# Hydraulic Design Report Addendum

## Belcaro – Oak Springs Canyon Creek

April 2026

HYD24-00005

Figure 2: Original Design at Oak Springs Canyon Road Culvert and Future J Street

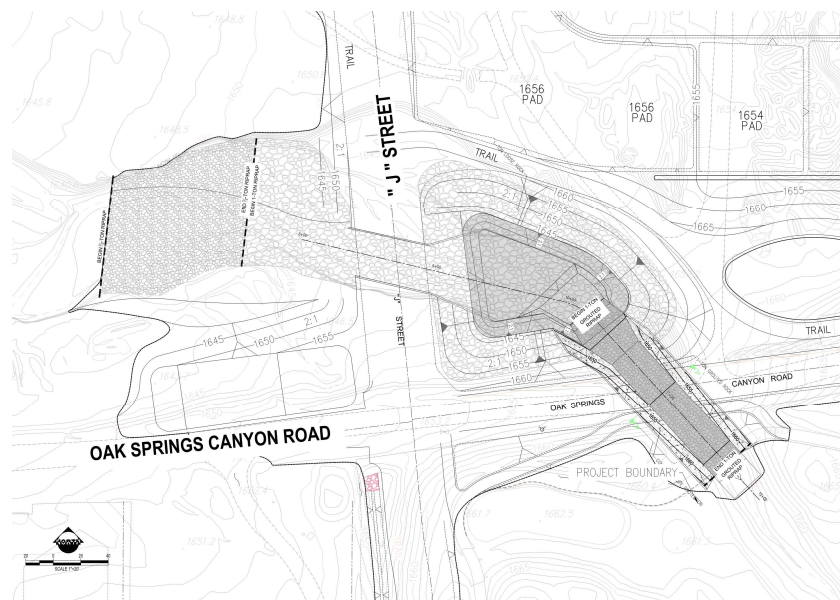
Because there has been historic erosion in Oak Springs Canyon Creek, there is an existing vertical drop of approximately ten feet downstream of Oak Springs Canyon Road. The design proposed in the original series of engineering documents utilized rip rap and grouted rip rap to dissipate energy and protect the channel as shown on Figure 2.

Although the original design retained an open channel between Oak Springs Canyon Road and future J Street, the client had some concerns about aesthetics, material costs, and public safety. At the request of the client, the proposed creek protection, between Oak Springs Canyon Road and future J Street, was revised to utilize a safer, more economical, and more aesthetically pleasing design. This design addendum describes the design revision, and includes hydraulic analysis, floodplain mapping and results discussion, which demonstrate that the revised design is functionally equivalent to the original proposed design.

The revised utilizes a broken back culvert to provide the necessary energy dissipation. The design follows guidance in Hydraulic Engineering Circular 14, Hydraulic Design of Energy Dissipators for Culverts and Channels. The culvert features a steep upstream section to create supercritical flow, and a flat downstream section that creates a hydraulic jump to dissipate hydraulic energy. The upstream section is steep enough to create high flow velocity necessary for a strong hydraulic jump. The downstream section is long enough so that the hydraulic jump is contained within the culvert.

The revised design combines two separate crossing structures and energy dissipation elements in to a single continuous culvert that conveys flow from upstream of Oaks Springs Canyon Road, to downstream of future J Street, as shown on Figure 3.

The area between Oaks Springs Canyon Road and Future J Street will be filled in and landscaped. This will provide better aesthetics than the grouted rock lined channel section of the original design that would allow no vegetation growth. The revised design will also eliminate the safety hazard of the deep channel with steep walls, present in existing conditions and in the original proposed design.
